Agenda
Planning Commission Meeting
Wednesday, January 26, 2022
Join the Zoom meeting [here](#)
Public Telephone Access: (206) 337-9723 or (253) 215-8782
Meeting ID No. 939 0409 3882

- I. CA2021-108 Badger Mountain South Land Use Development Regulations (LUDR) Amendments

AHBL, Inc. on behalf of NorAm Investment, Inc. is proposing various amendments to the Land Use & Development Regulations (LUDR), which act as the zoning regulations for the Badger Mountain South Planned Unit Development community.

Building Placement Diagram (Plan View)

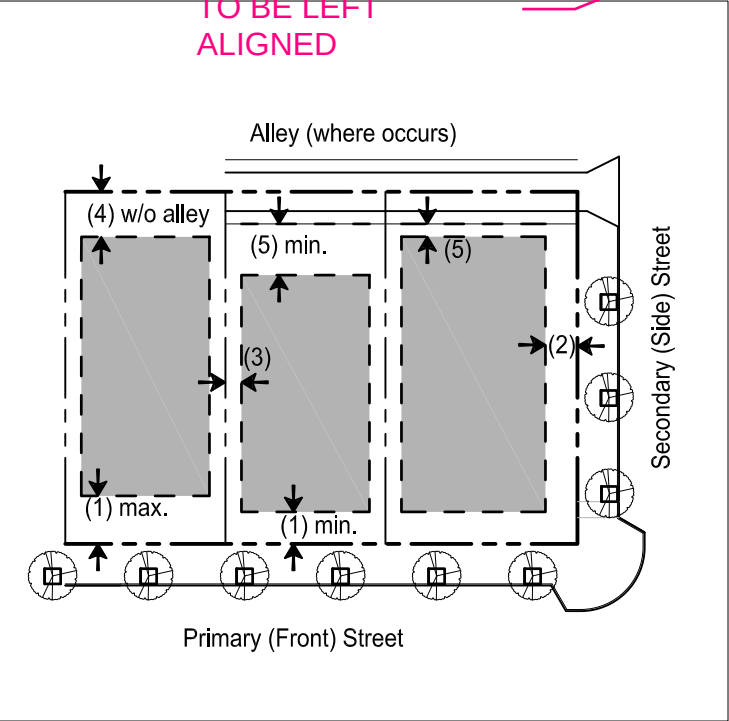
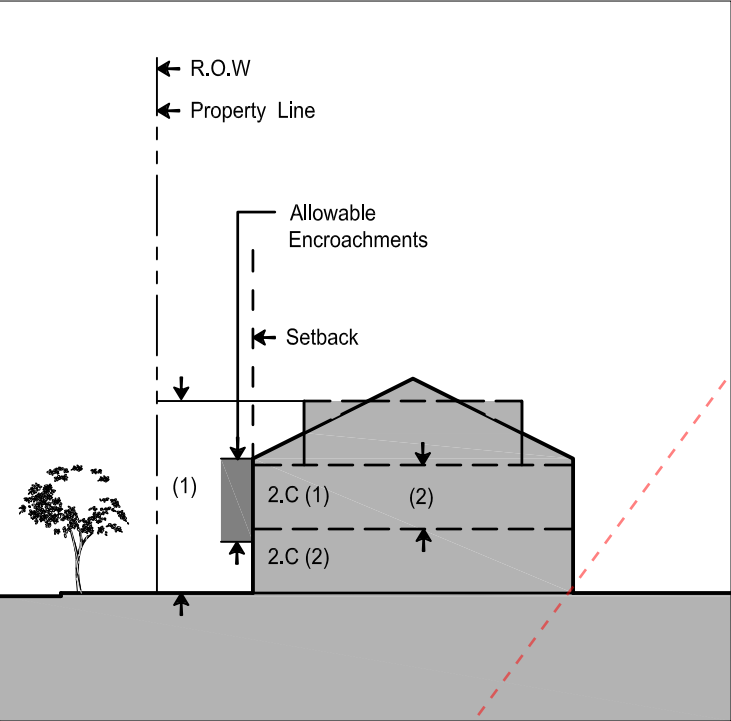
CHANGE POSITION TO BE LEFT ALIGNED

6.C 4-LANE ARTERIAL COLLECTOR STREET

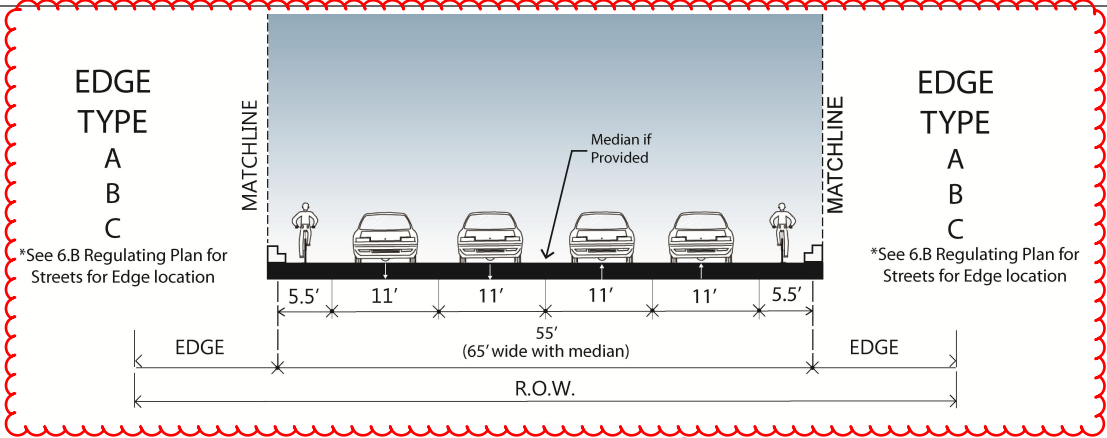
PROPOSED AMENDMENTS ARE SHOWN:

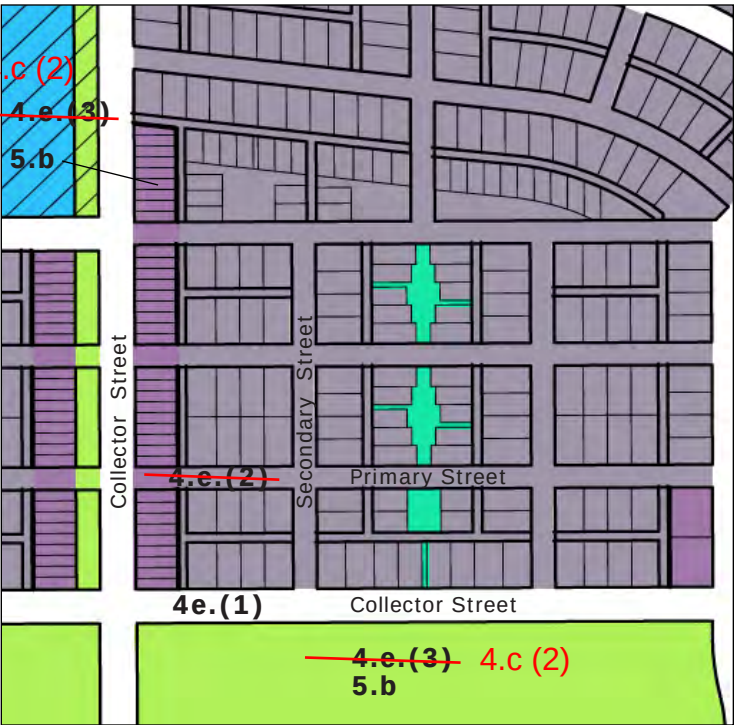
Remove 2.b and 2.c labels
